Tillbridge Solar Project
EN010142

Volume 9
Statement of Common Ground with Trent Valley
Internal Drainage Board
Document Reference: EN010142/APP/9.14

Figure 1: Trent Valley Internal Drainage Board Crossings

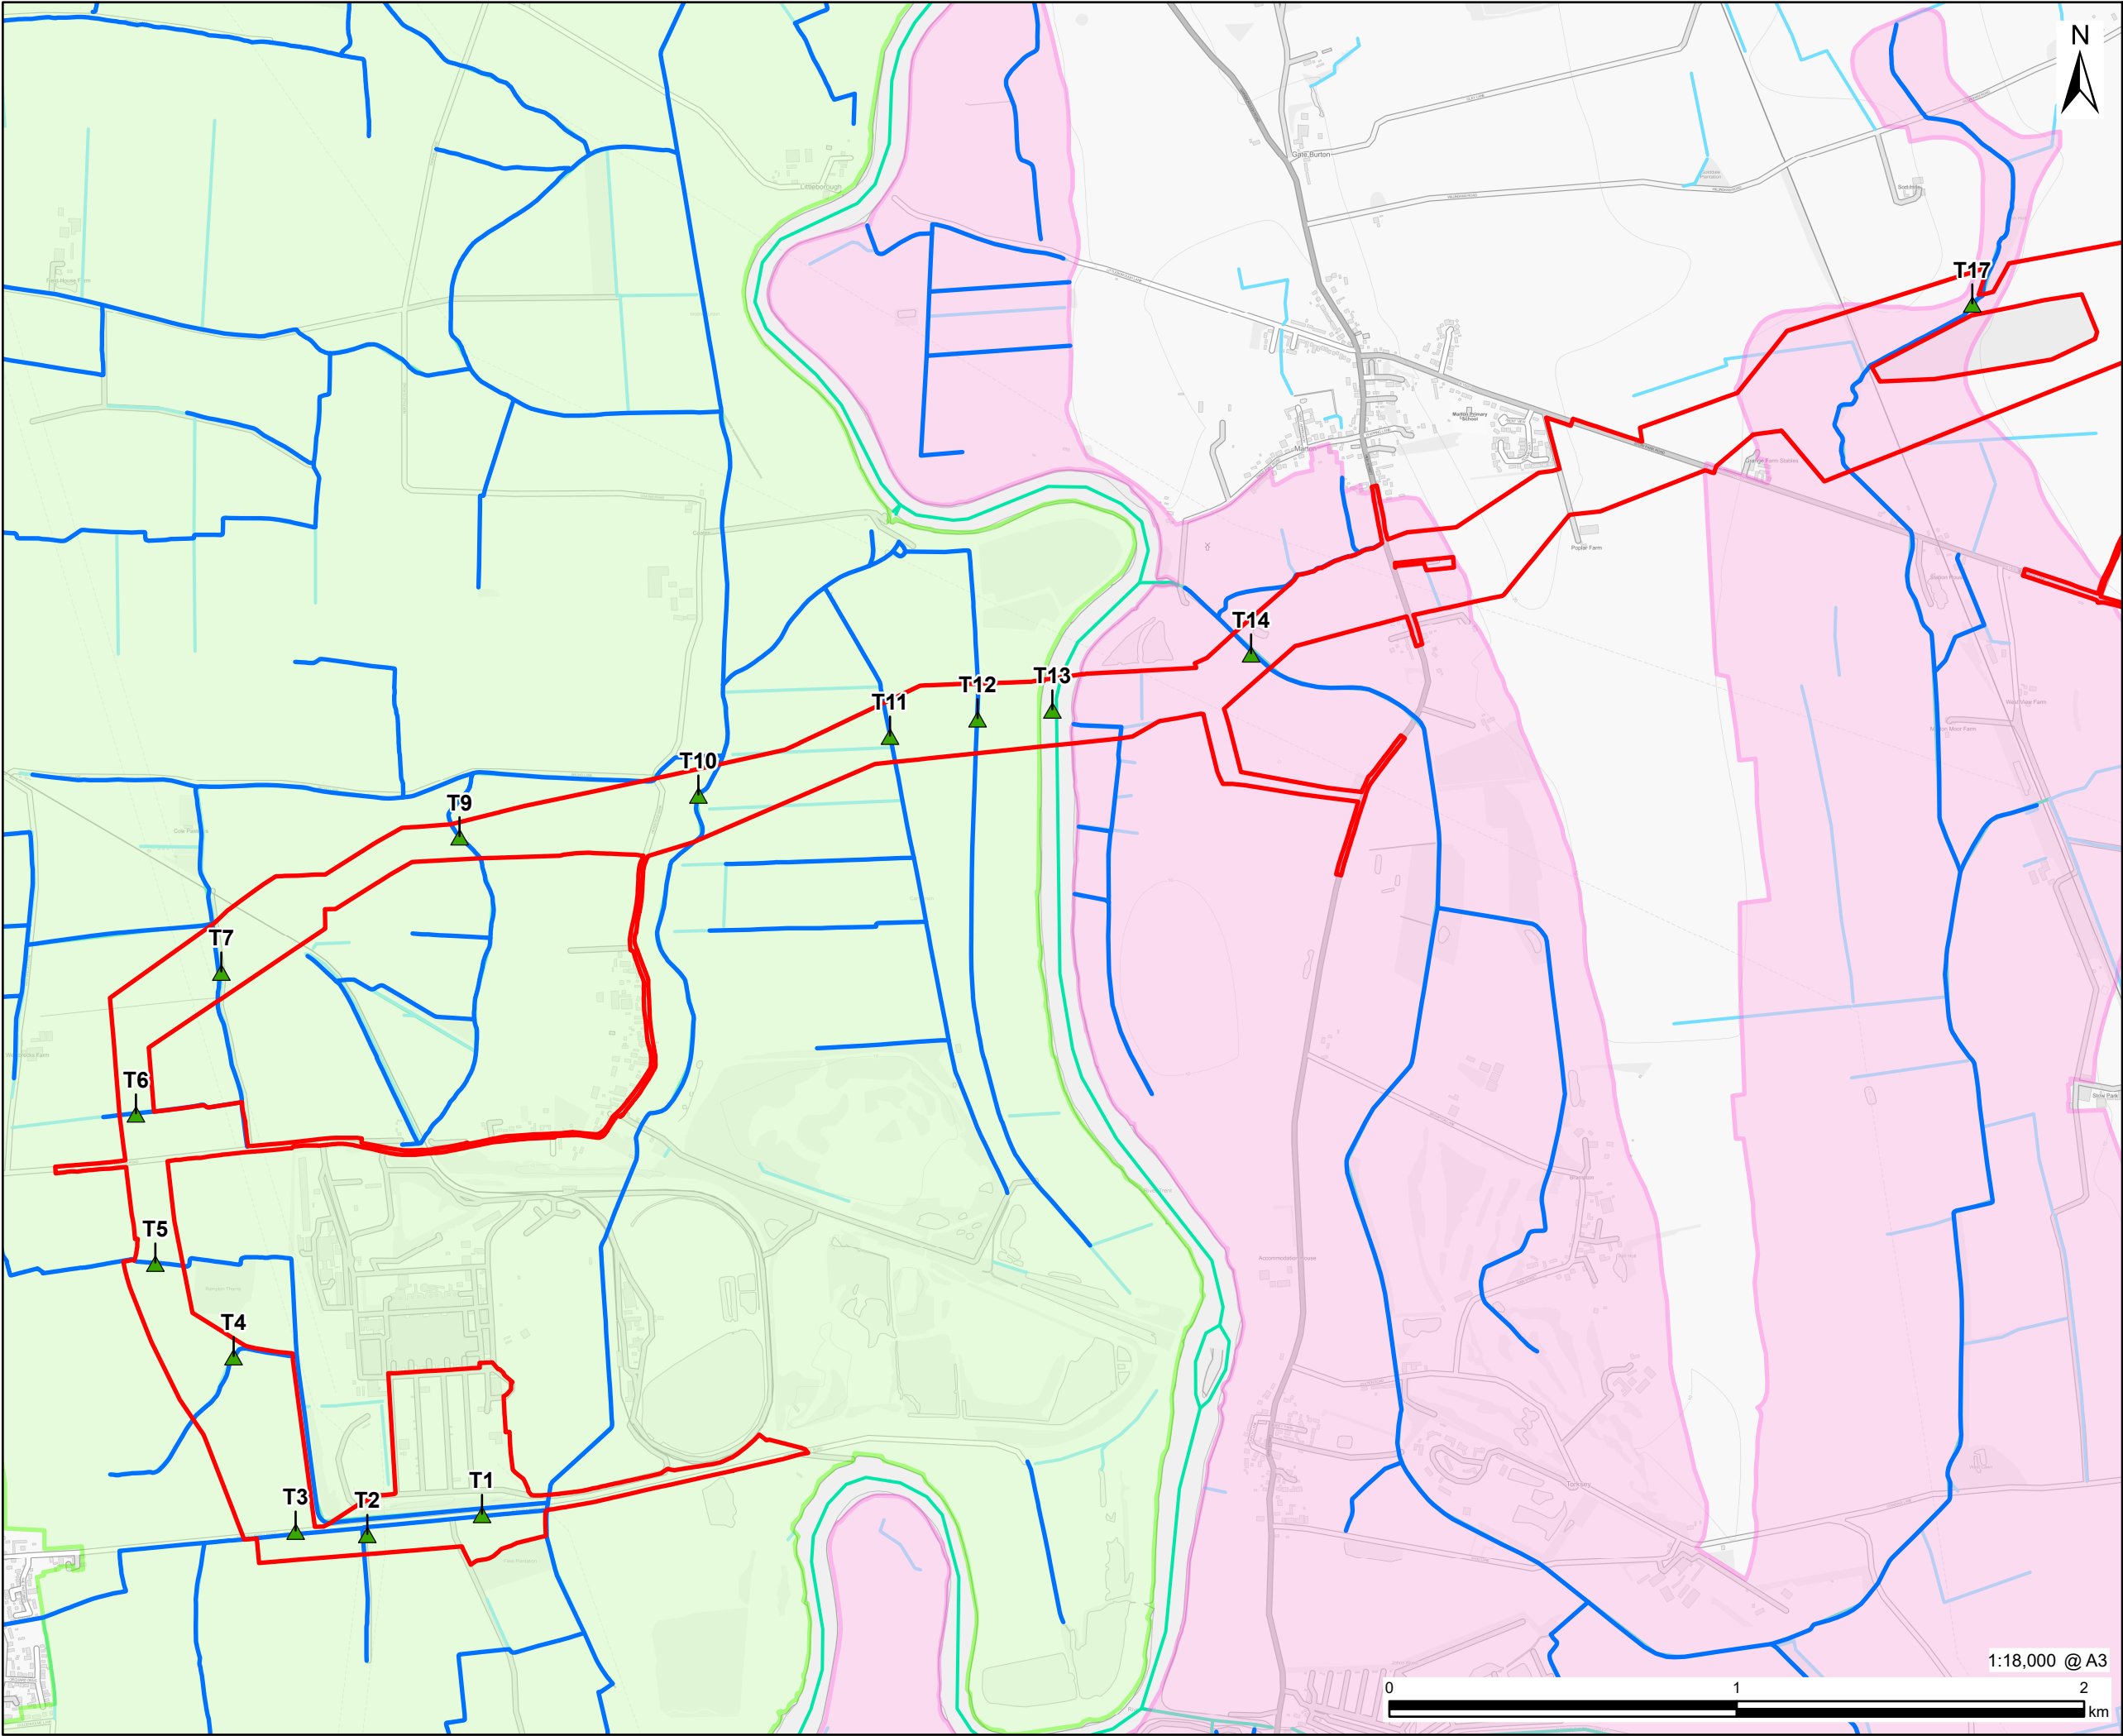
Ref.	Relevant Application Document	Description of Matter	Status	Likelihood of Resolution
Additional Consultation September 2023				
1.1	Chapter 10: Water Environment of the ES [EN010142/APP/6.1(Rcv01)]	<p><u>TVIDB's Comment:</u> All Channels in TVIDB to be crossed using trenchless (non-intrusive) techniques.</p> <p><u>Applicant's Response:</u> This has been included within the Scheme design.</p> <p>This is stated within Section 10.7 Embedded Design Mitigation of Chapter 10: Water Environment of the ES [EN010142/APP/6.1(Rcv01)], set out within the Framework CEMP [EN010142/APP/7.8 (Rcv01)] and the location of the crossings is illustrated by Figure 1 within Appendix A of this SoCG.</p>	Agreed – TVIDB comment has been resolved.	Resolved
